ARROWHEAD RANCH INFRASTRUCTURE

BRIDGE AND CHANNEL IMPROVEMENT

UNION HILLS DRIVE AT SKUNK CREEK

ADDENDUM NO. 1
TO
ARROWHEAD RANCH INFRASTRUCTURE
BRIDGE AND CHANNEL IMPROVEMENT
UNION HILLS DRIVE AT SKUNK CREEK

Detour Curve Data
 $\Delta = 15^\circ 02' 57.5''$
 $R = 818'$
 $T = 108.05'$
 $L = 214.88'$

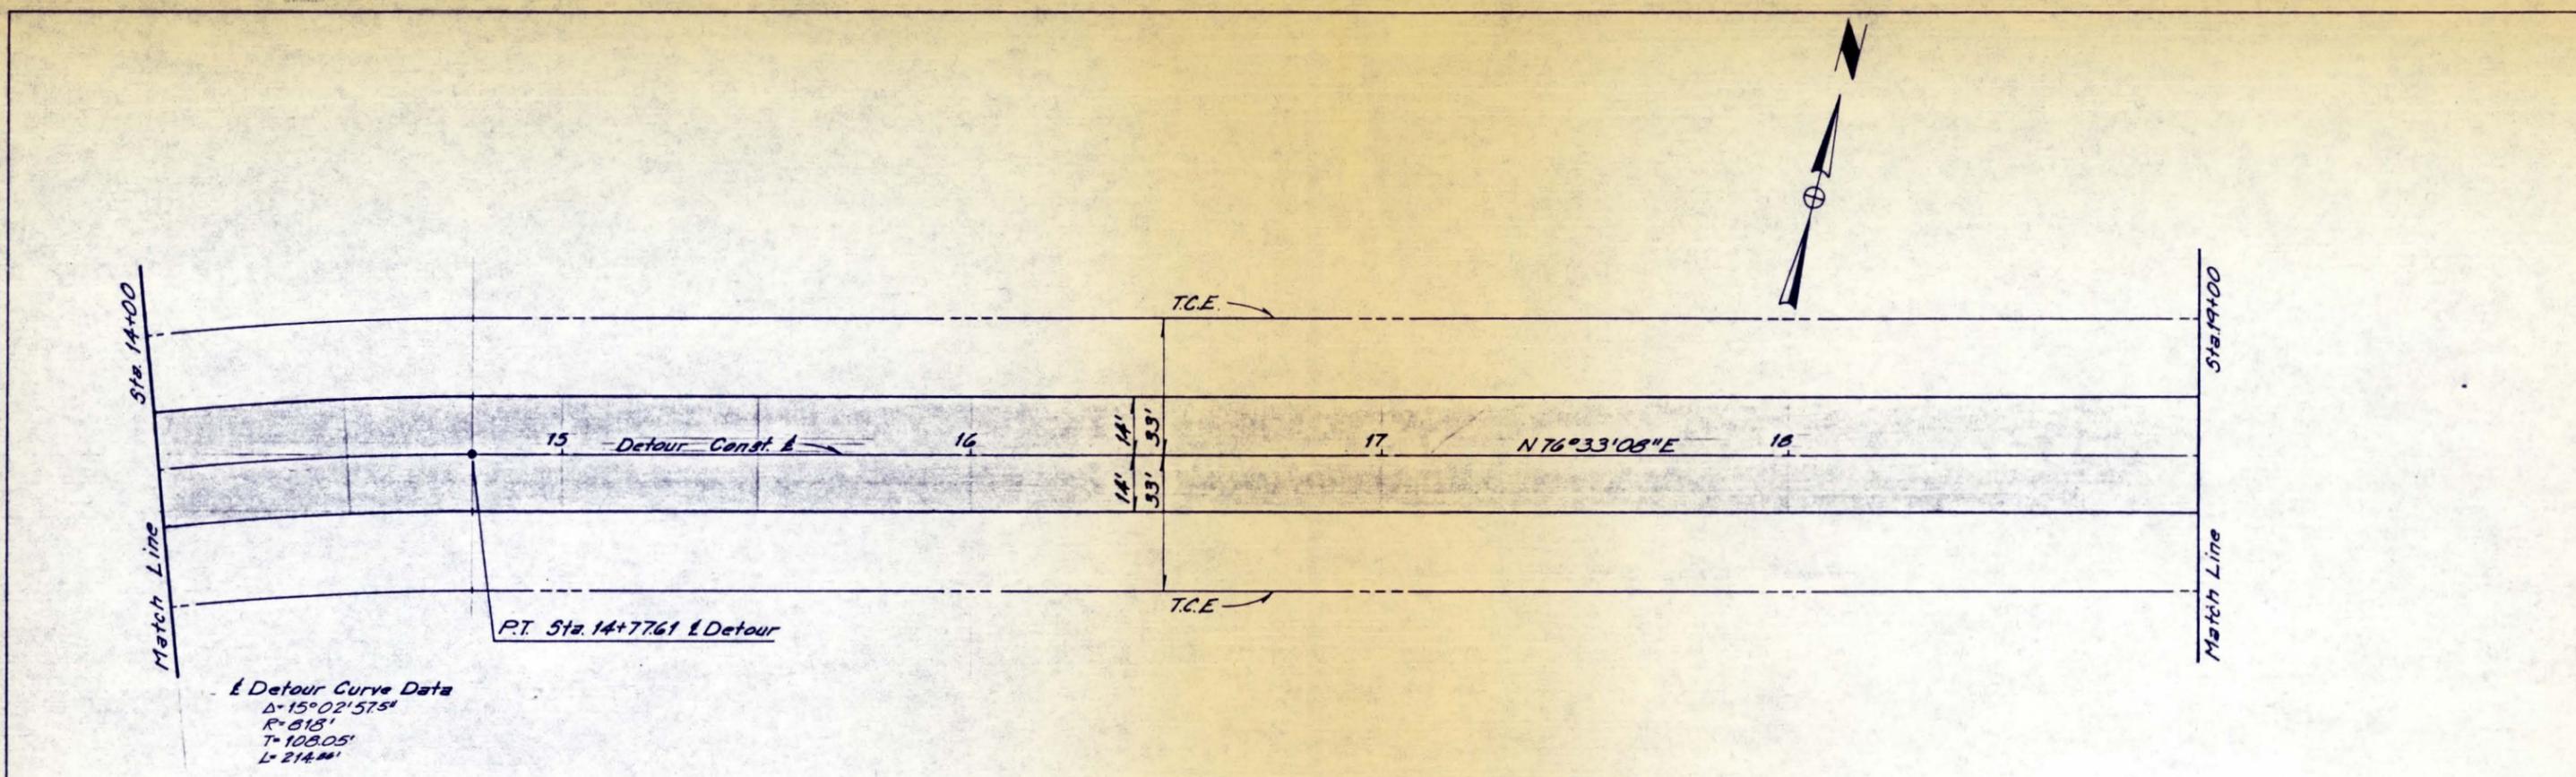
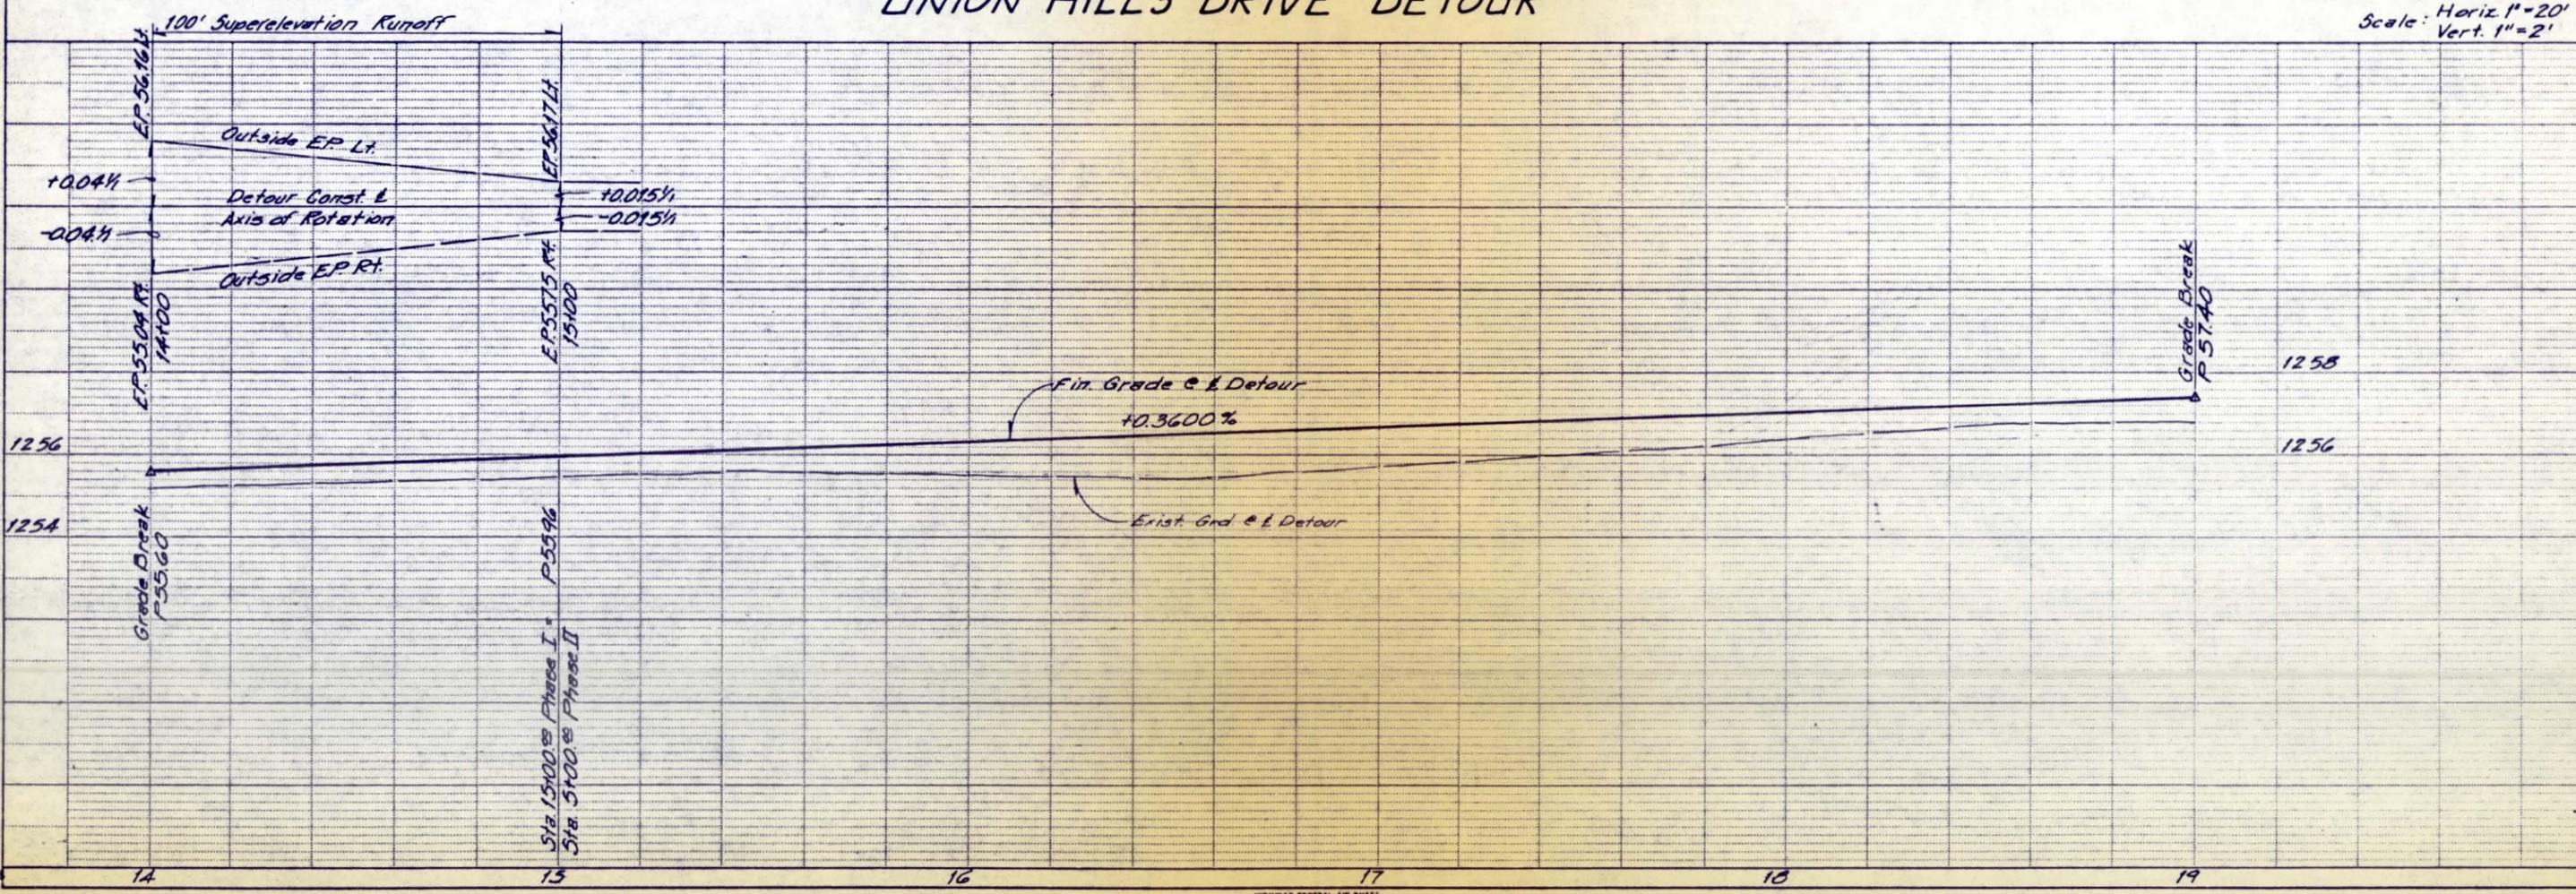
Delete Detour Sheets 2 through 6 from the Plans and insert therefor half-size Phase I Sheets 2A and 2B (new Plan and Profile Drawings) and Sheets 3 through 6 (which have new stationing) attached to this Addendum.

NEW THREE SPAN CONTINUOUS CAST-IN-PLACE POST-TENSIONED CONCRETE BOX GIRDER BRIDGES

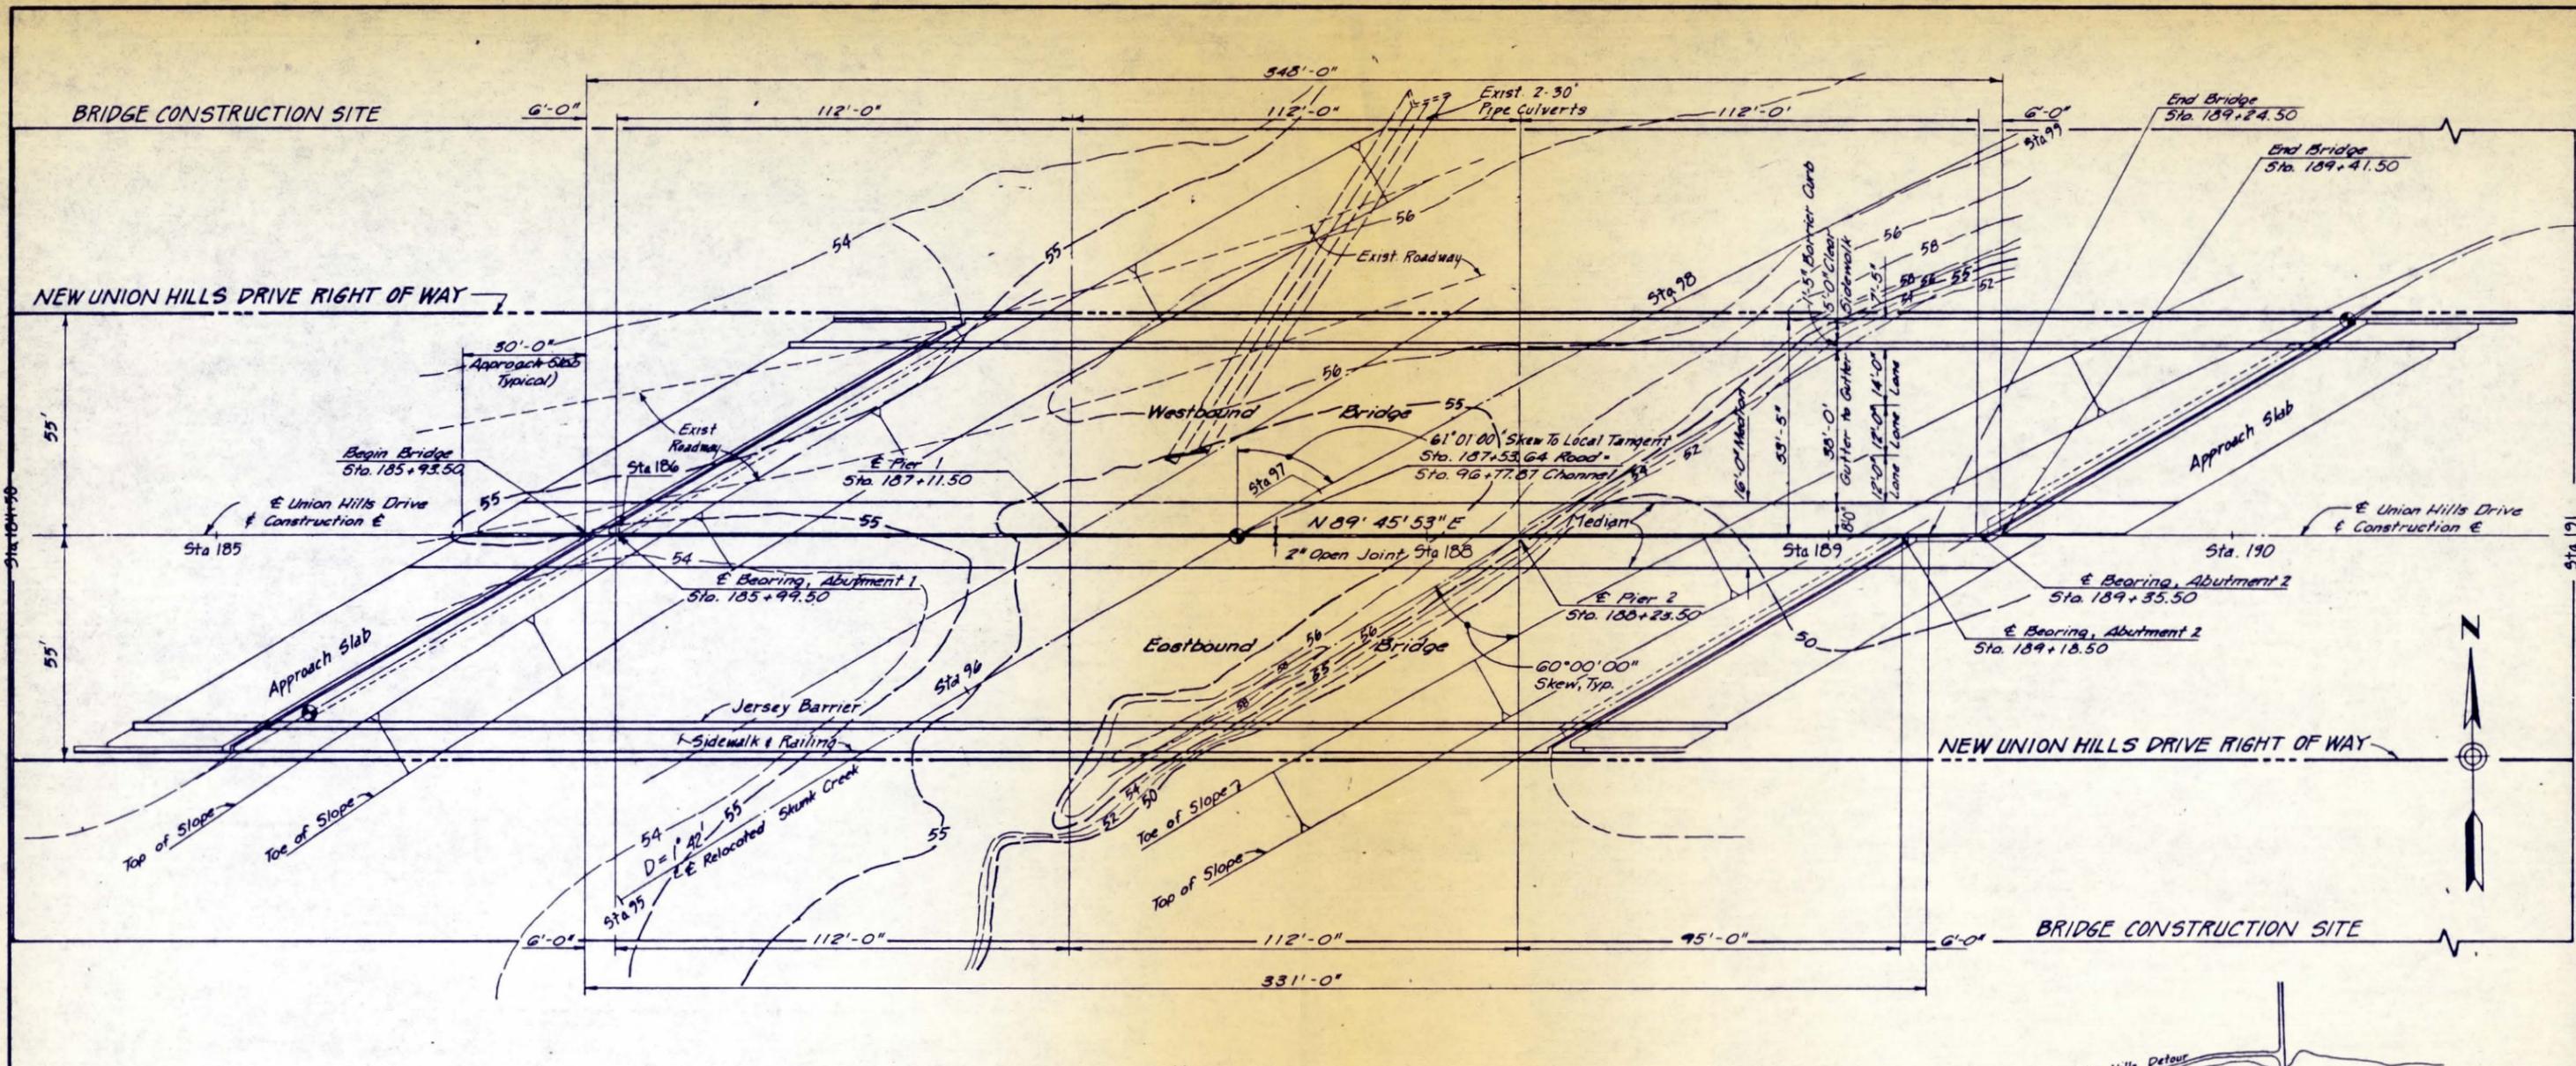
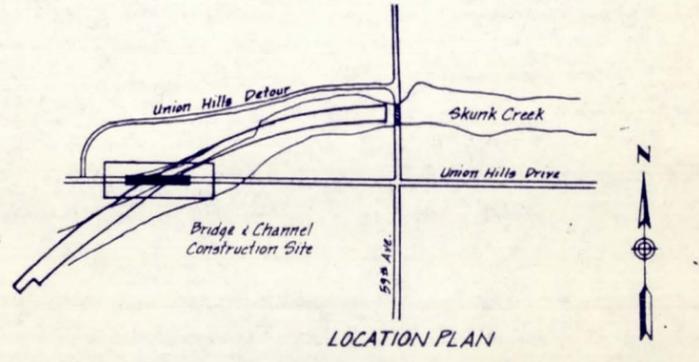
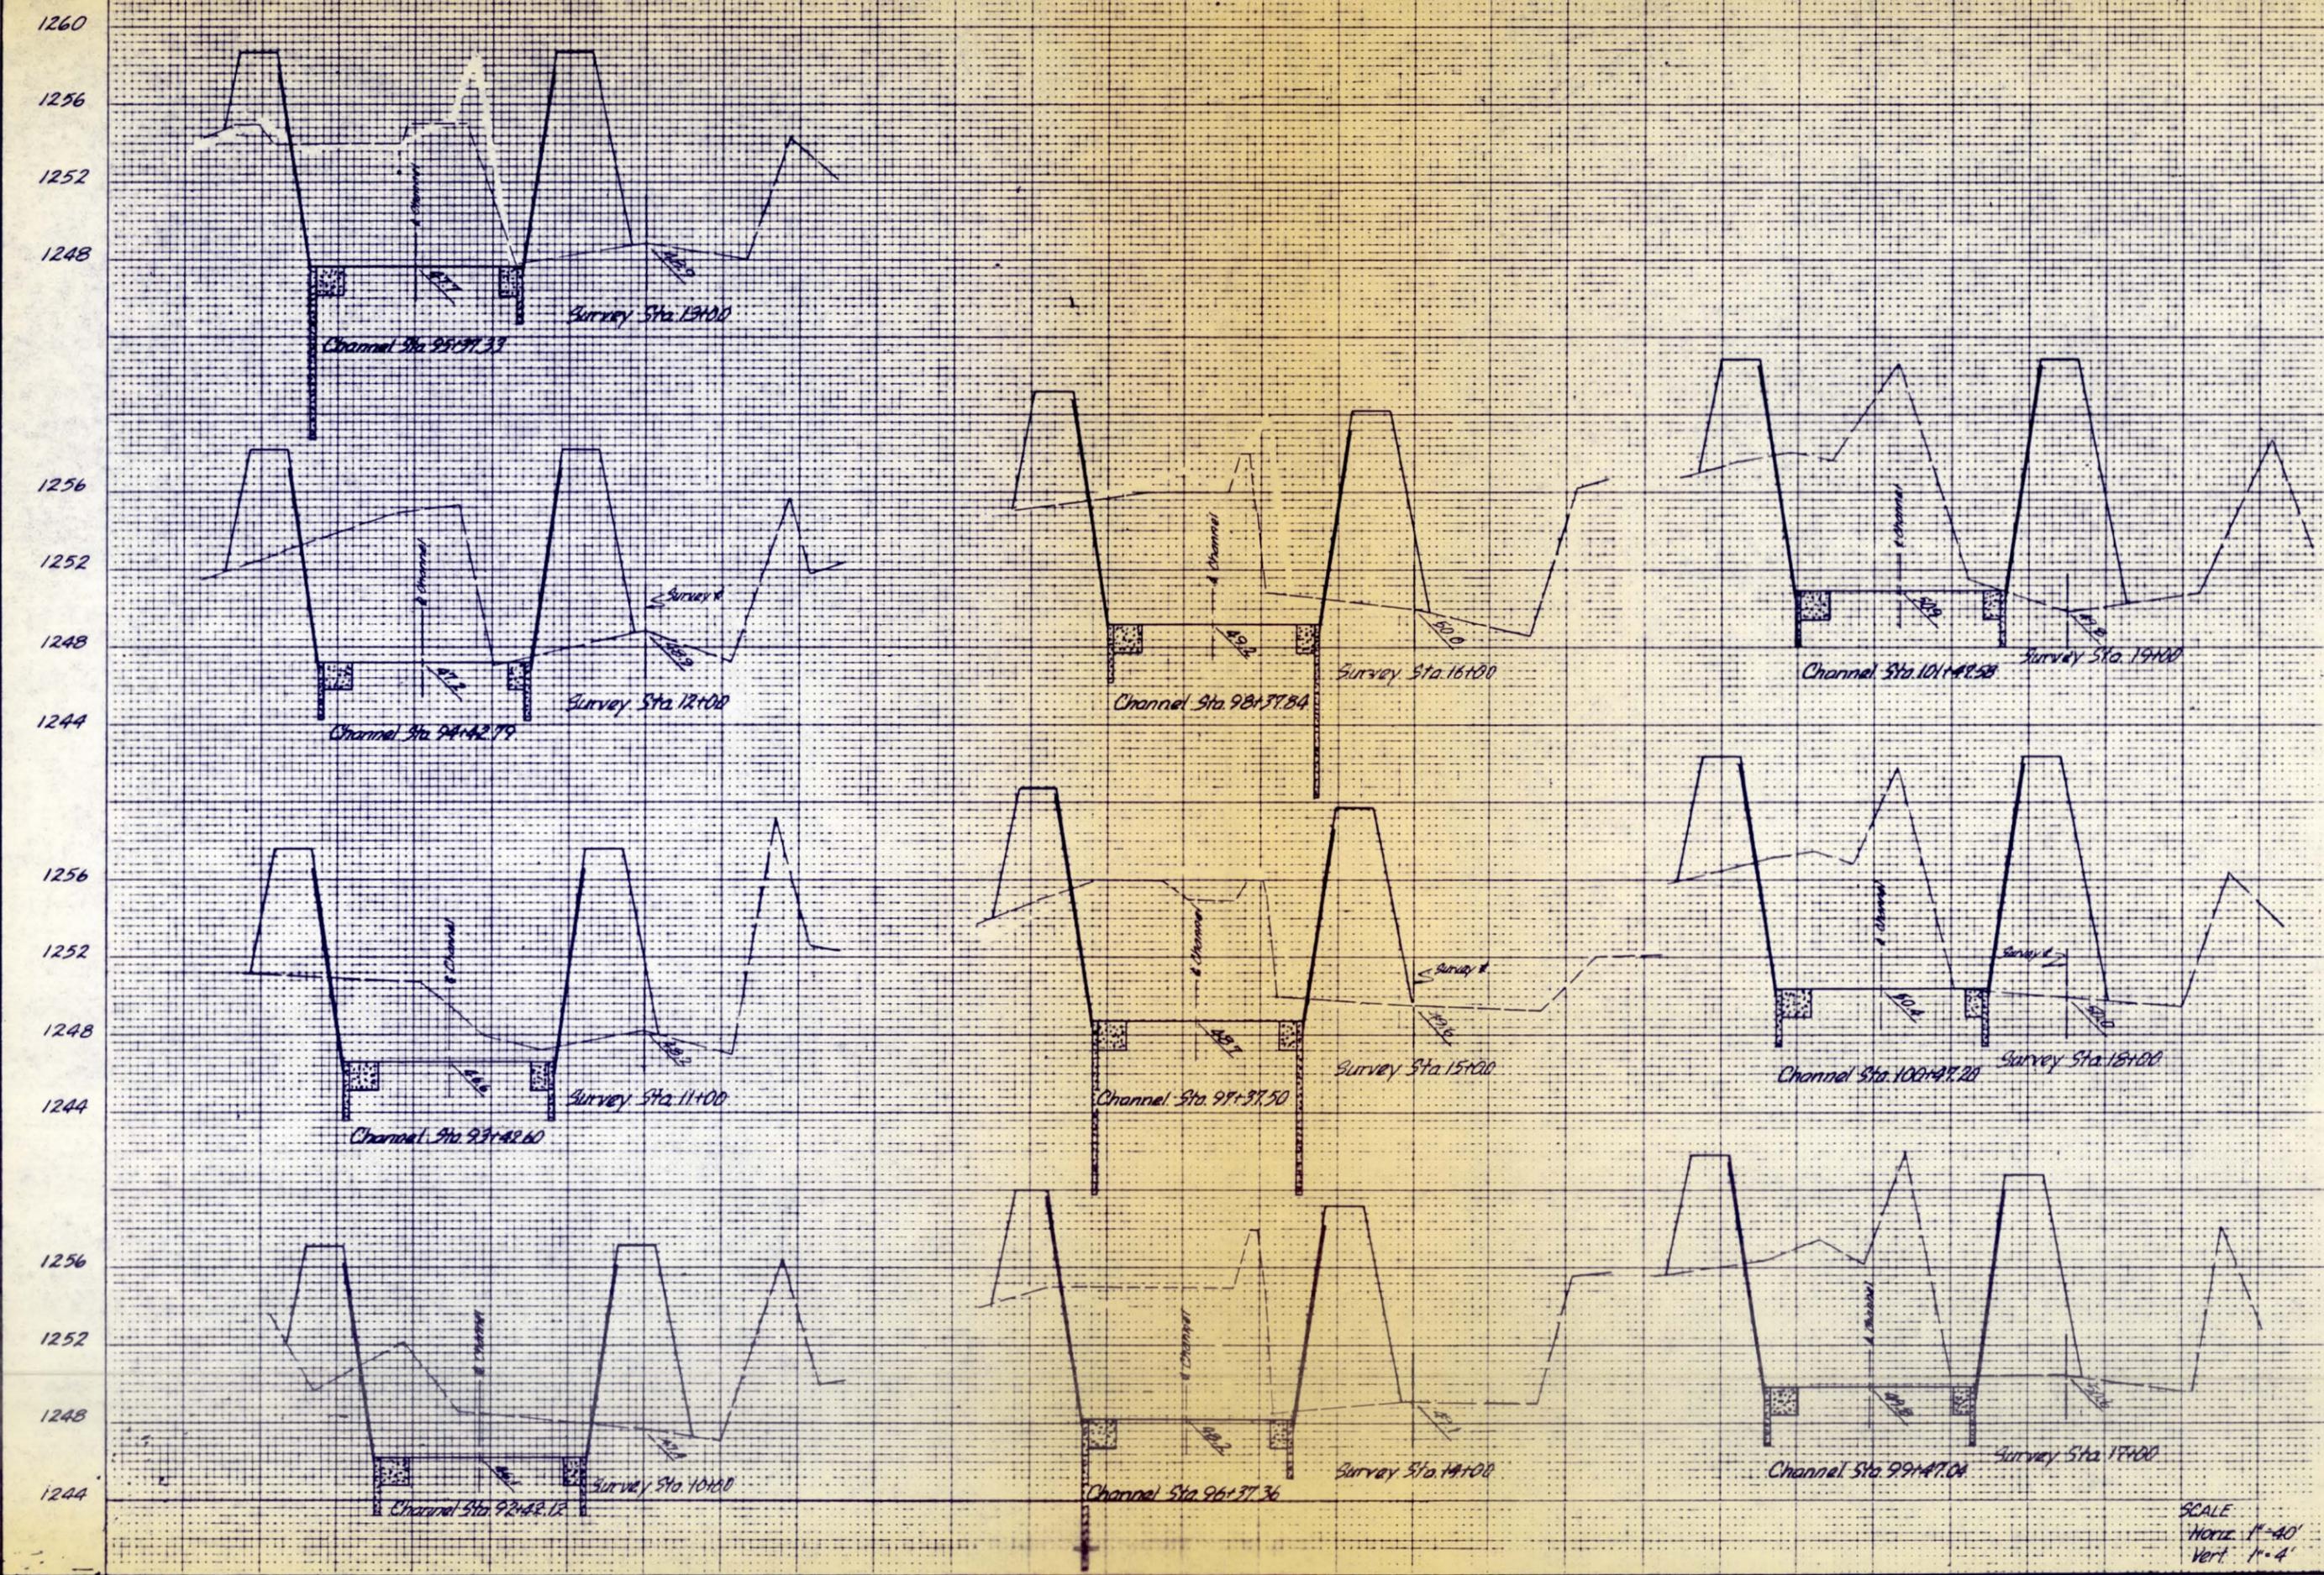
Delete Sheet 8 of 34 and insert therefor half-size Sheet 8-Rev. 1, attached to this Addendum. The existing ground contours have been redrawn in proper relation to Union Hills Drive and the new bridge.

On Sheet 8, on the small location plan, indicate between the Union Hills Detour and the Bridge Construction Site, Designated Stockpile Areas for excess material from other Arrowhead Ranch Infrastructure Projects, for Contractors use in the work.

On Sheet 8 under Construction Details and on Sheet 13, Section C-C, the expansion joint shall be of waterproof strip seal type across the street and ADOT Std. RJ-3 across the sidewalks. The median joint may remain open. Transverse joints in the raised median shall be at 20 foot intervals. Acceptable deck joint assembly manufacturers are listed on a separate page attached to this Addendum. Installation of weatherproof strip seal and RJ-3 at sidewalks are detailed on the detail of Deck Joints attached to this Addendum.
